From: JEROME HANSEN <jha2570@comcast.net>
Sent: Tuesday, June 11, 2019 12:26 PM
To: Herman, Jason, NMENV
Cc: John Durham; Thompson, Terry
Subject: [EXT] Jerome Hansen's letter of protest
Attachments: J. Herman letter 5-23-2019.pdf

Re: Renewal of DP-465 S&R Septic Service Discharge Permit

Figure 3. The Waste Mgmt well near the site.
(From Benson, 2004)

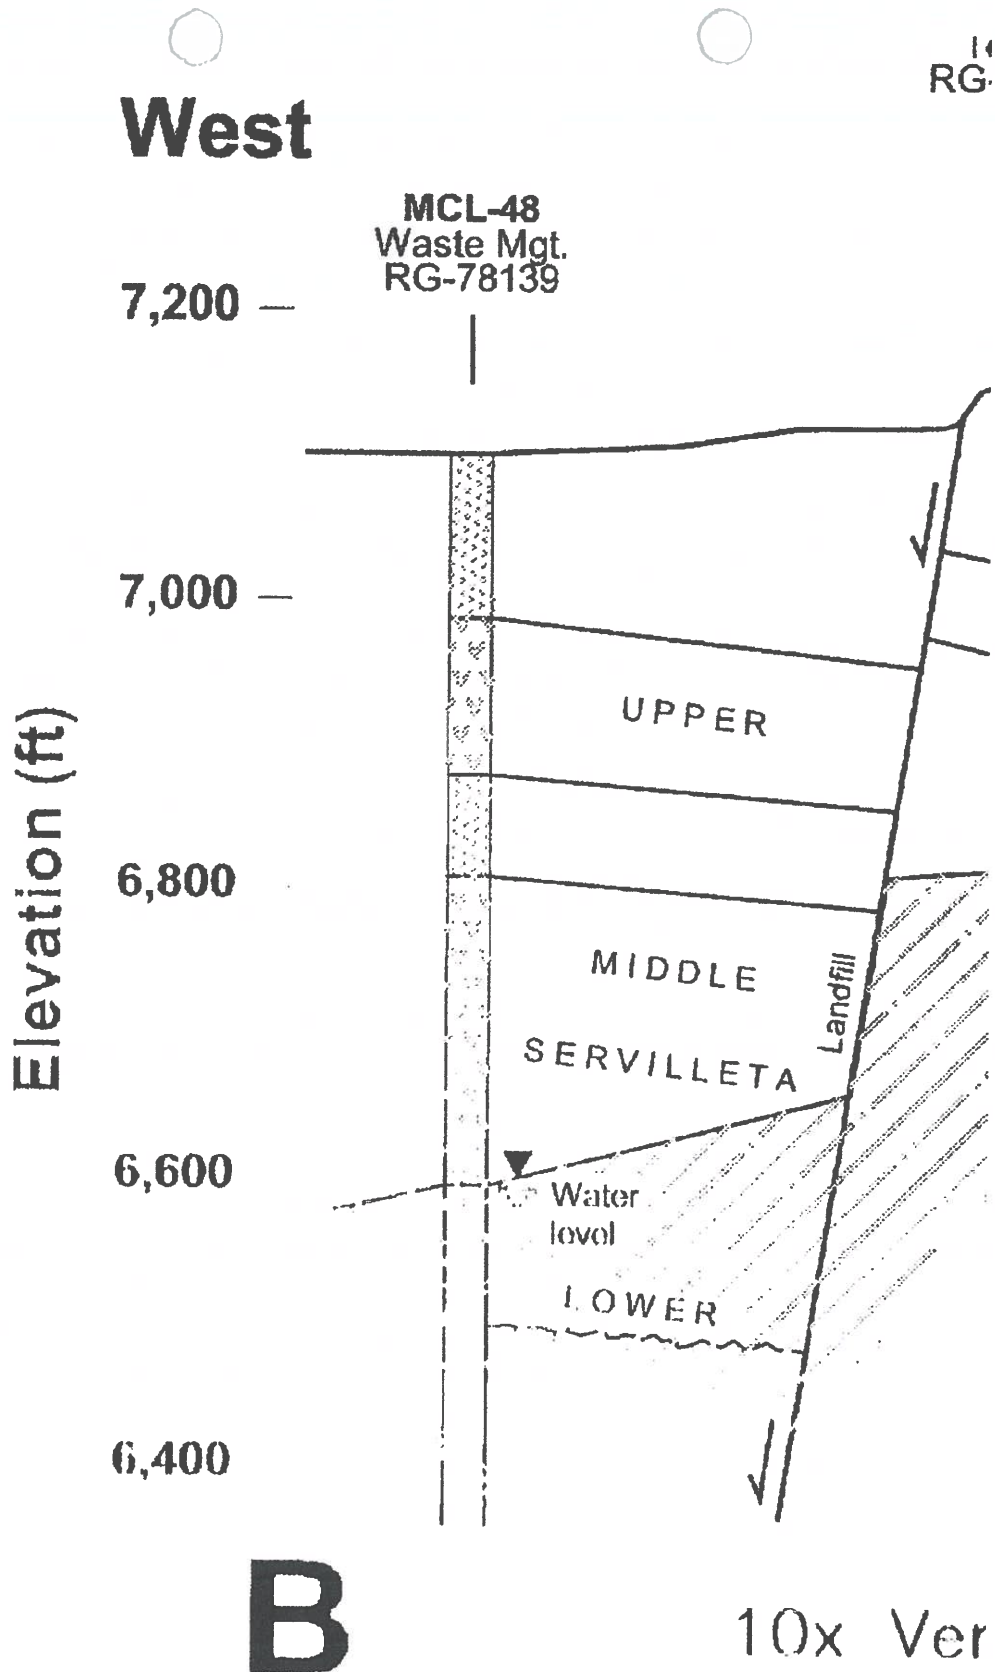
Contamination of the groundwater below the water table may result from nearby water wells. One well, RG-78139, is 1140' from the cells. RG-78139 was drilled with an 8" bit and cased with 5" SCH 40 PVC pipe. The casing was not cemented to the borehole, leaving a 1.5" ring of void space between the borehole wall and the casing. This "annulus" extends vertically from the surface casing to the water table and to the bottom of the well. The annulus was packed with gravel during the well completion, but this gravel pack is not sufficient to isolate the water table from effluent from above. If effluent reaches this borehole, via the alluvium or the basalt, it has essentially an open conduit to the water table below (Figure 6). The only thing that may keep it from entering the annulus is a thin amount of drilling mud cake in the borehole wall. There are no records of either packers or cement in the well. The well should be monitored closely for signs of communication with the lagoons. Although it is 1140' from the south edge of the cells, an effluent plume only needs to move at a rate of 37 feet year to reach this borehole. Thus it is critical to know where the effluent is in the subsurface, and to know where it is moving. If it is moving toward this well, it should be properly plugged by drilling out the PVC casing and gravel pack, setting 5" steel casing, cementing the annulus to the surface and setting cement plugs in the casing.

Figure 4. The 32 year line has been interpolated onto the "fine sediment above coarse sand" chart. Effluent depth is ~ 84'. Fine sediment over gravelly sand would be deeper, maybe 100-110'.

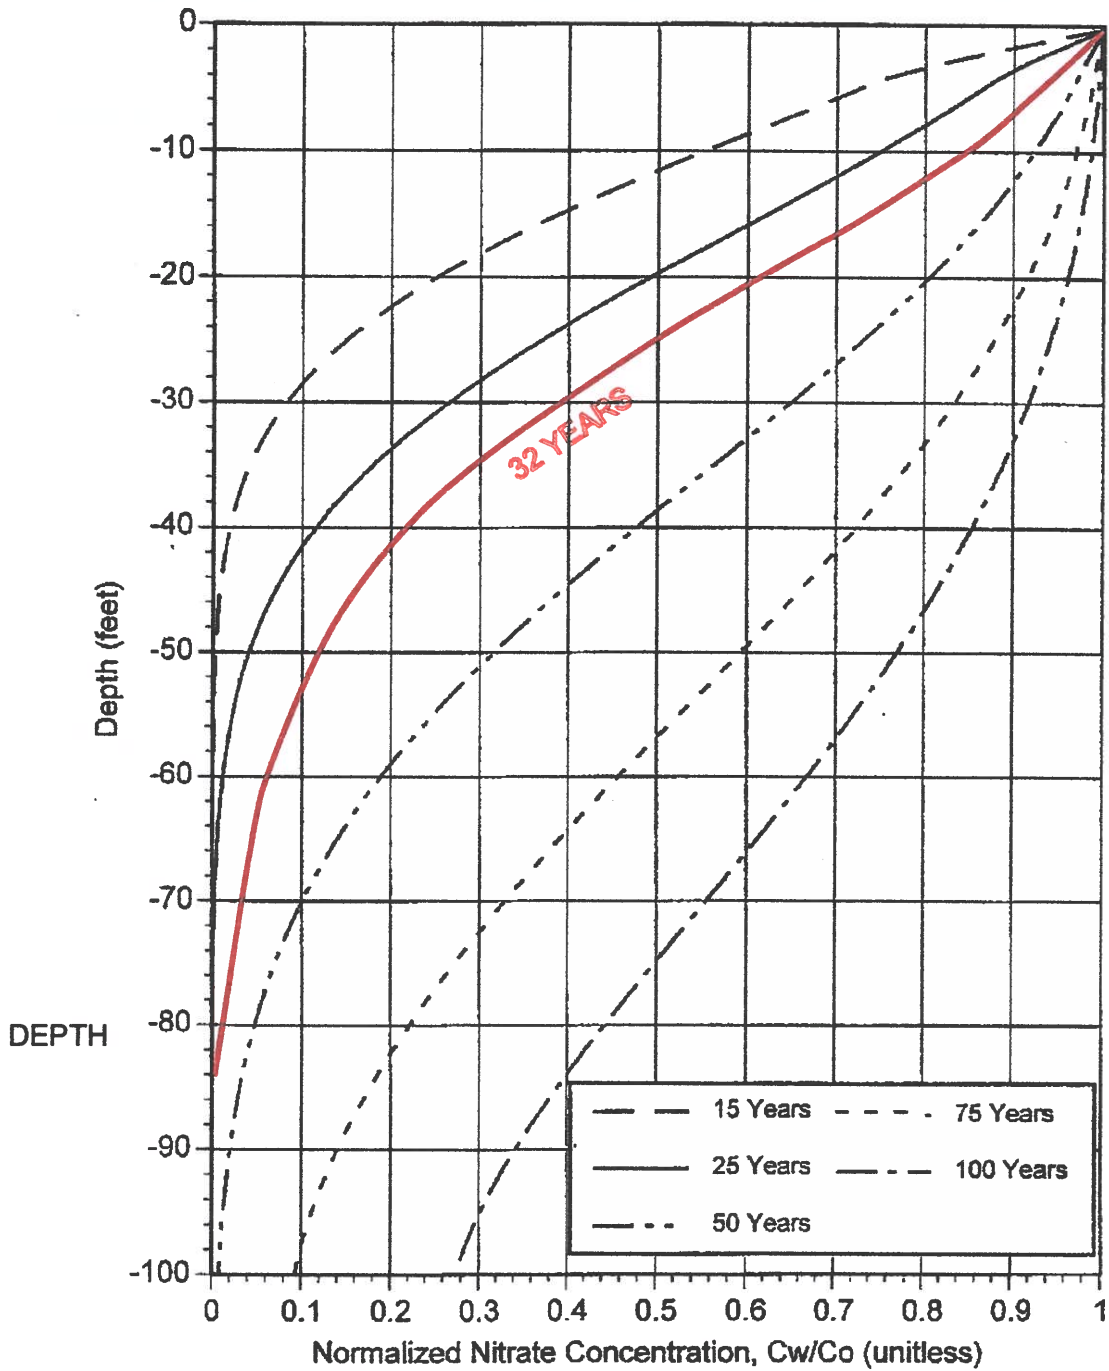
of nitrate over time. I have extracted Figure 17 from this report (Fine grained layer over coarse sand) and have interpolated the 32 year timeline onto this figure (my Figure 4). At 32 years, this model predicts the depth of effluent (i.e. zero nitrates) to be ~84 feet. However, Duke describes the upper 30 feet at the Taos site as "gravelly sand", which is likely to be substantially more permeable than their coarse sand model. Thus it is likely that effluent has penetrated to depths of more than 100, the depth of the Upper Basalt.

Figure 7. The septic system 7/2018.

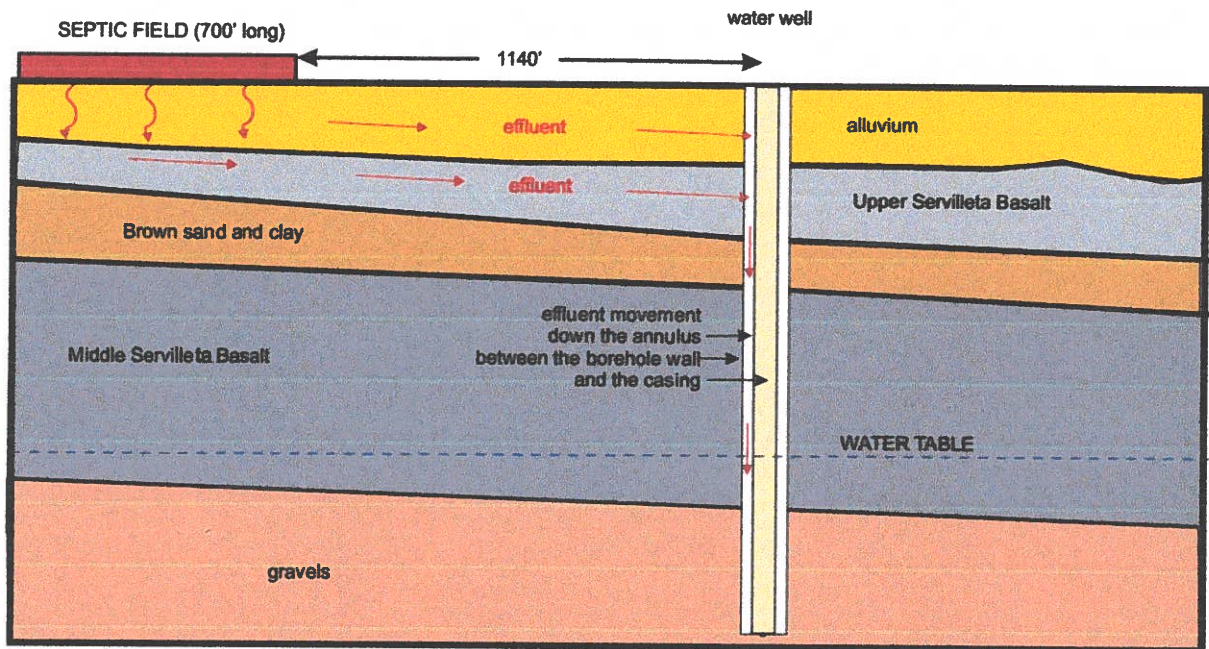
down by microbial action, and the water is clear and free of vegetation. This water is clean and does not pollute the aquifers. In contrast, these cells are choked with verdant, green weeds that indicate that the waste is being converted into fertilizer instead of being consumed by aquatic bacteria (Figure 7). In addition to the odor and flies, the problem is that the pathogens in the waste have not been consumed and are free to leach downward toward the water table.
